# Executive Director's Recommendation

<b>PROJECT</b> <b>New Monumental Arch</b> George Washington Memorial Parkway Memorial Avenue Washington, DC	<b>NCPC FILE NUMBER</b> 8778
<b>SUBMITTED BY</b> United States Department of the Interior	<b>NCPC MAP FILE NUMBER</b> 1.45(73.10)46209
<b>REVIEW AUTHORITY</b> Federal Projects in the District per 40 U.S.C. § 8722(b)(1) and (d)	<b>APPLICANT'S REQUEST</b> Approval of comments on concept plans
	<b>PROPOSED ACTION</b> Approve comments on concept plans
	<b>ACTION ITEM TYPE</b> Staff Presentation

# New Monumental Arch

Approval of Comments on Concept Plans

# Monumental Arch: Ceremonial Axis Site Plan

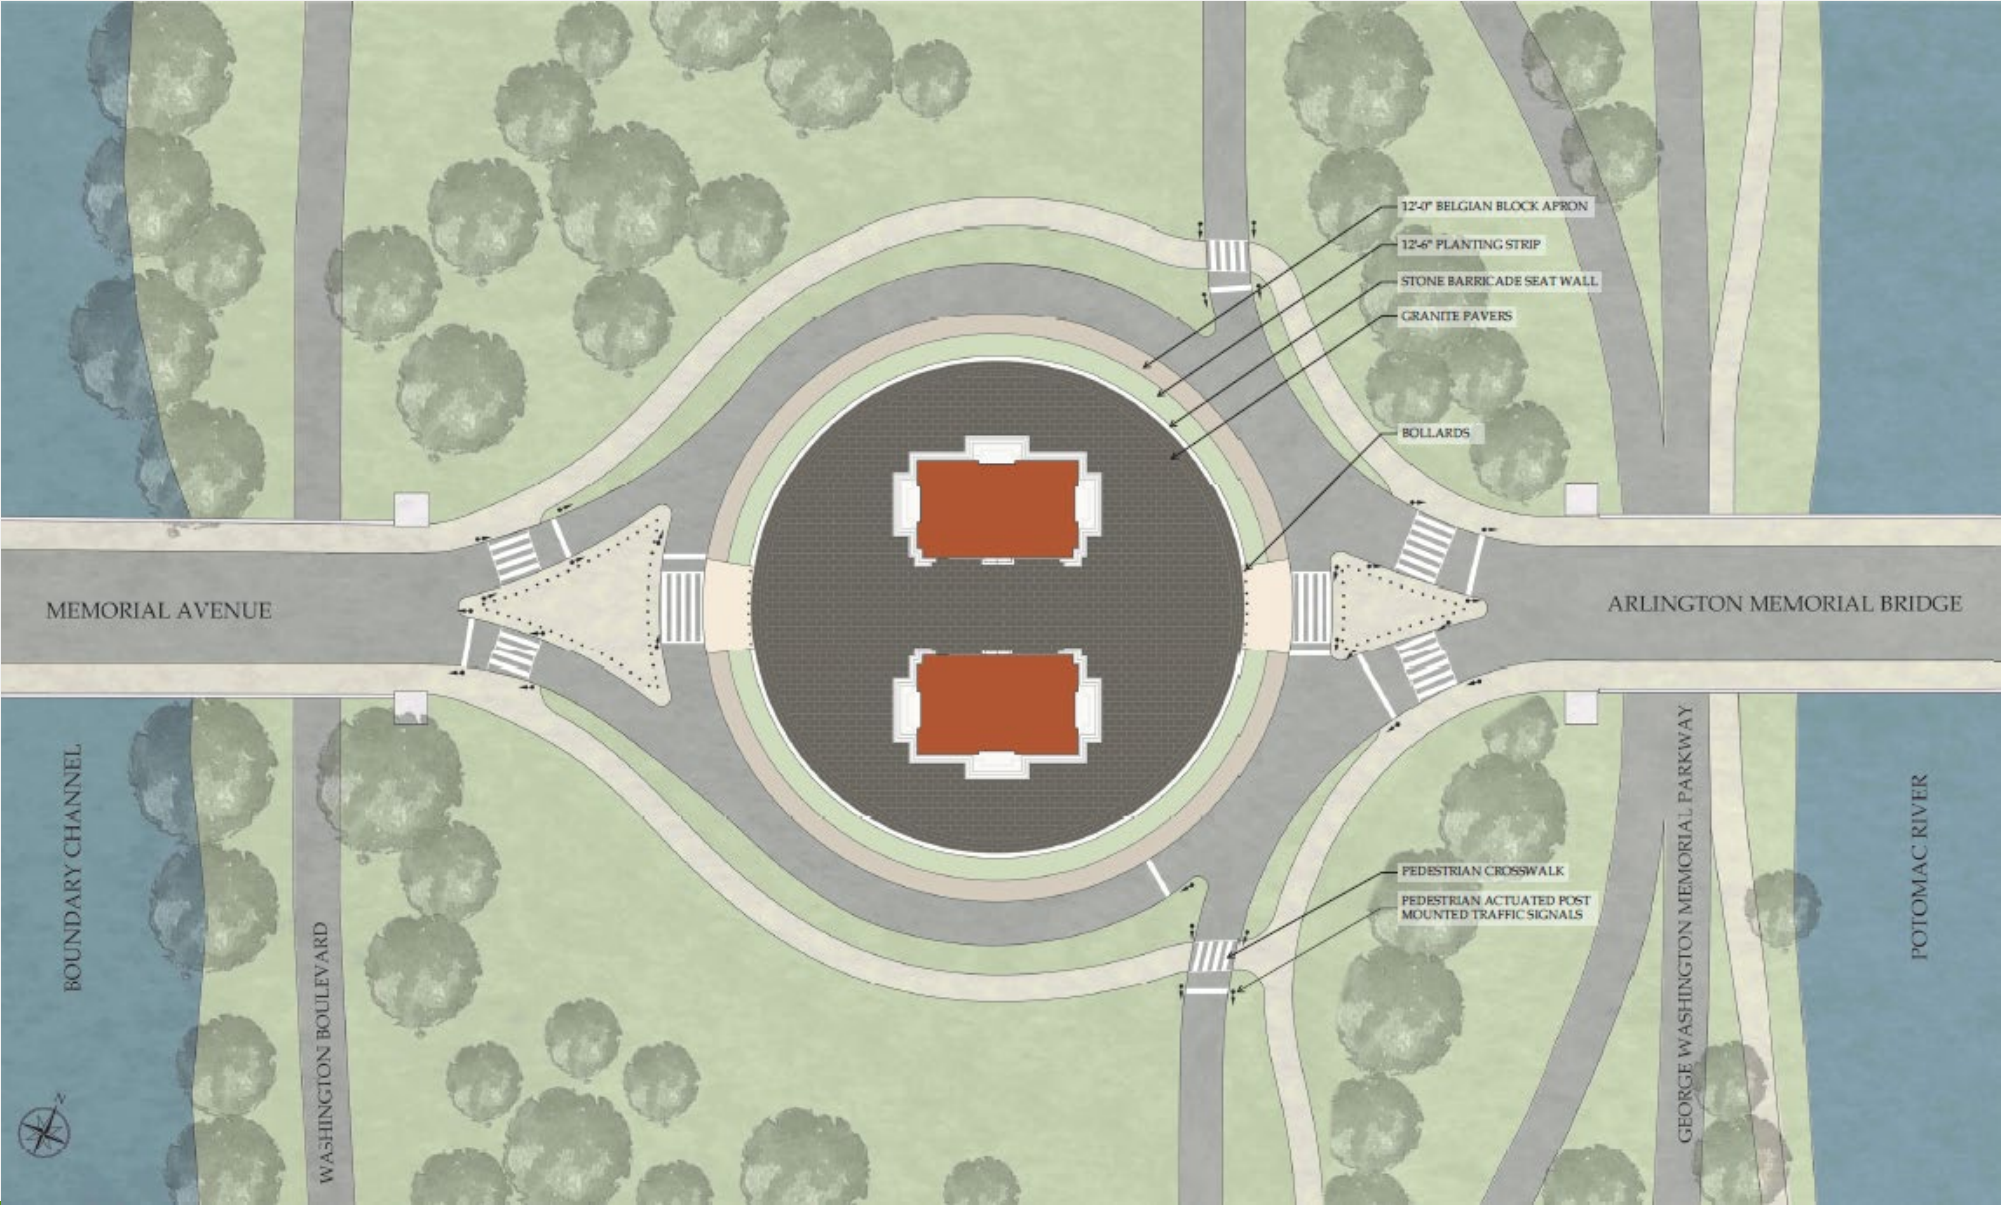
**Notes** that visitors cannot currently access the center of Memorial Circle, and the applicant proposes to alter the east triangular island and provide crosswalks on the east and west sides of the circle. However, the plans do not provide details regarding visitor parking, loading/unloading, and Americans with Disabilities Act (ADA) access.

The plans include new pedestrian crosswalks from the west at Memorial Avenue which meet as a traffic refuge, before proceeding across the Circle into the arch plaza. From the east, two new crosswalks will start at the landing of the Memorial Bridge, also merging into a traffic island before crossing the Circle into the arch plaza. The applicant has stated that signals will be used to control vehicular traffic and allow pedestrians to use the various crosswalks.

- A transportation or traffic study that identifies any potential impacts of the proposed project on the road network and level of service, and evaluates the proposed pedestrian access to ensure that visitors can avoid pedestrian and vehicular conflicts; and
- Information regarding parking and loading/unloading for visitors to the arch to ensure safe access for those of all abilities and minimize disruption to the traffic network.

# Monumental Arch: Floor Plans

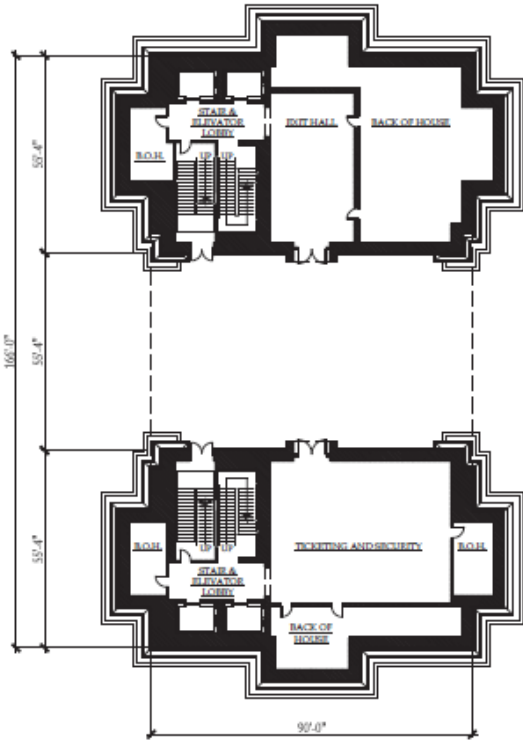
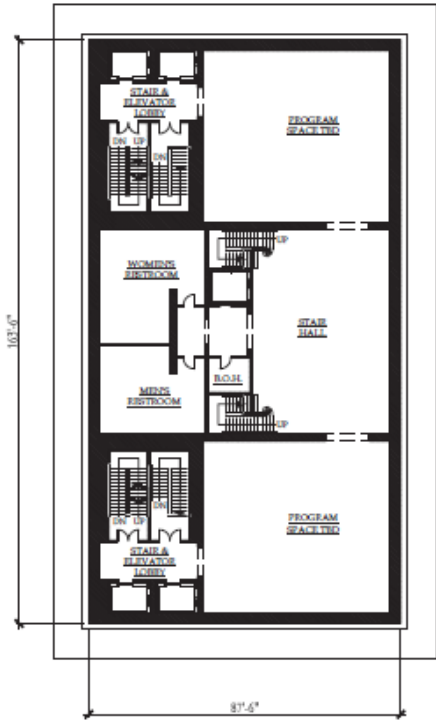
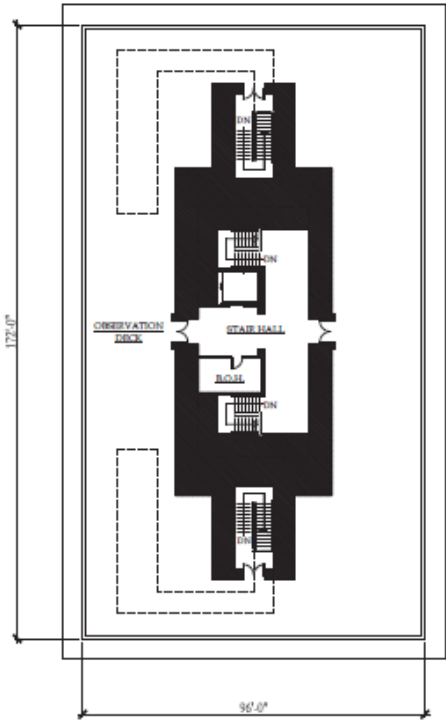
The proposed interior of the arch at the ground floor level includes ticketing and security, back of house space, stairwells, and elevators in the south leg, with an exit hall, back of house space, stairwells, and elevators in the north leg. The submission plans include a stair hall, restrooms, program spaces, and stair and elevator lobbies that connect up from the legs in the mezzanine. The stair hall includes two additional staircases and an elevator in the center to provide access to the observation deck above.
